DEVELOPMENT REVIEW BOARD  
**SUPPLEMENTAL SUBMITTAL**

PROJECT NO. PR-2018-001579

SUBMITTAL DESCRIPTION: Based on the comments from the DRB Hearing January 5, 2022 we requested a deferral

**RE: PR-2018-001579 – WINROCK TOWN CENTER, SI-2021-00304 SITE PLAN, SI-2021-00305 SITE PLAN AMENDMENT, SUMMARY PLAT (PLAT OF EASEMENTS ONLY)**

PROFILE VIEW: STORM DRAIN AP-A 100 IMPROVED

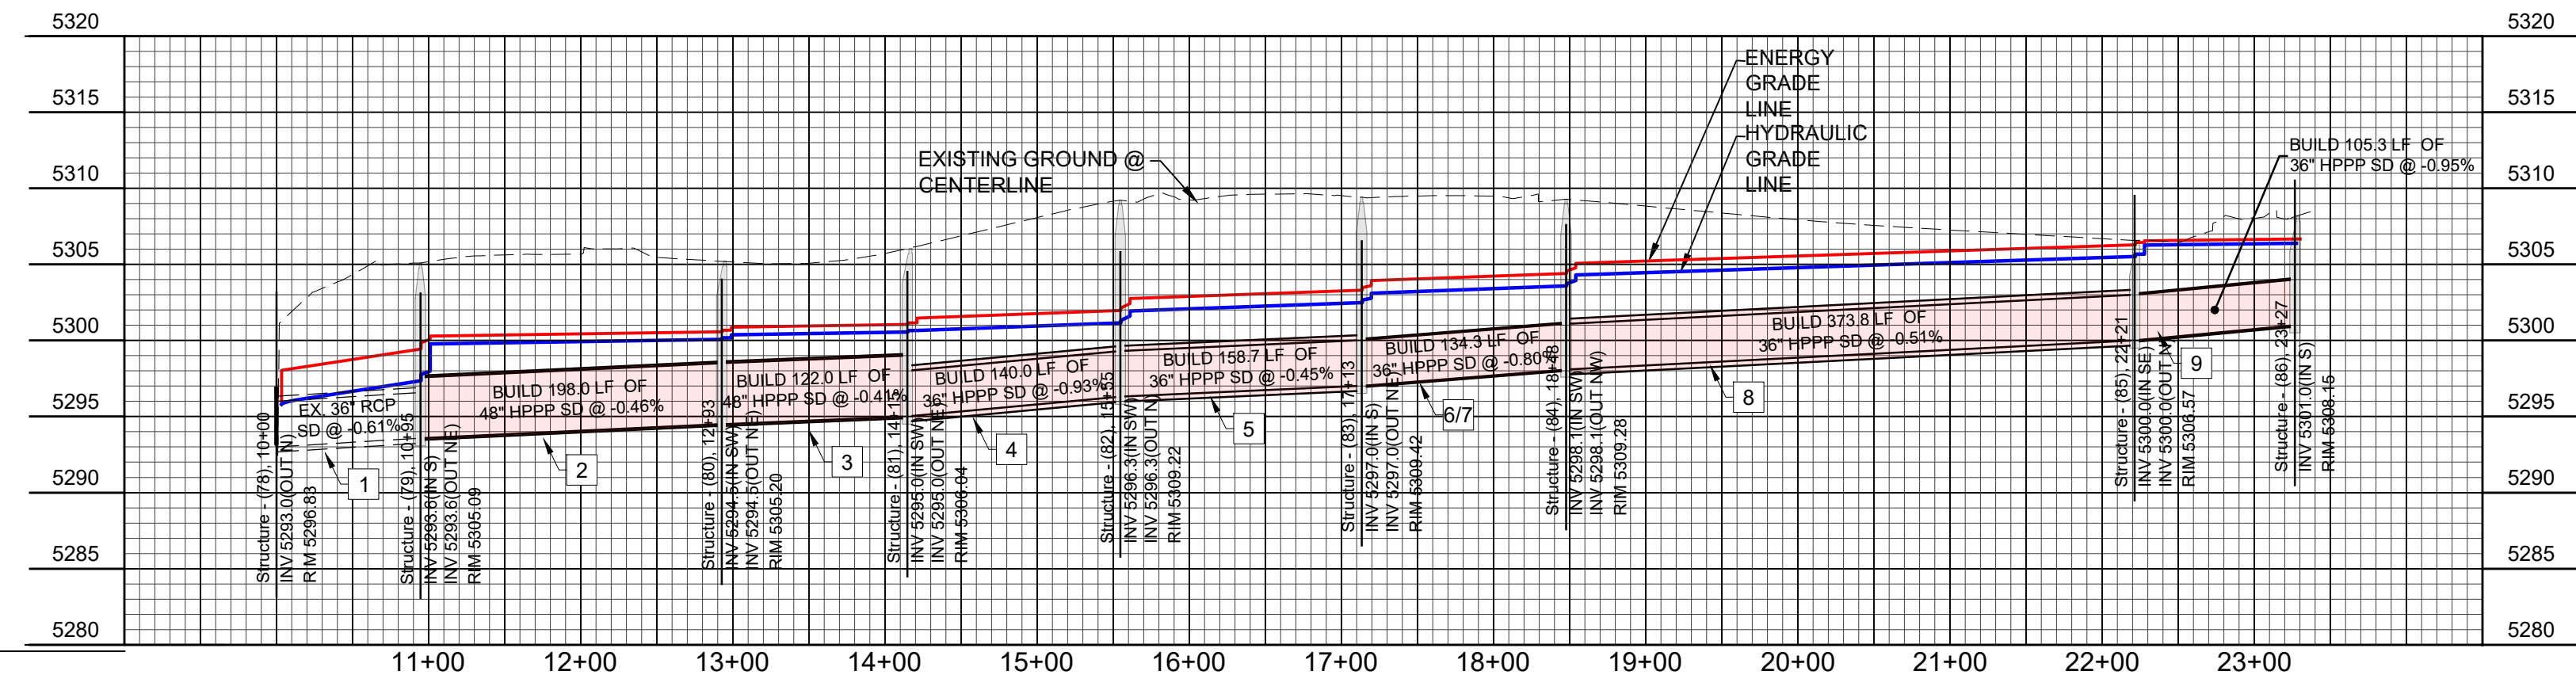
As presented within the DIP the existing storm drain network AP-A may have been incorrectly modeled for the revised flowrates in previous analyses. The existing storm drain pipes were originally designed to convey 46 CFS. With the revised development in that area, the peak flowrate of AP-A increased to 82 CFS which causes the existing pipes to have insufficient capacity during the 100-year storm event. Refer to Exhibit 8 for the existing condition of network AP-A. As a future solution to correct this pipe network, the storm drain should be upsized and/or replaced with an alternate material to safely convey the 100-year peak flowrate. Refer to Exhibit 9 for the proposed improvements to network AP-A.
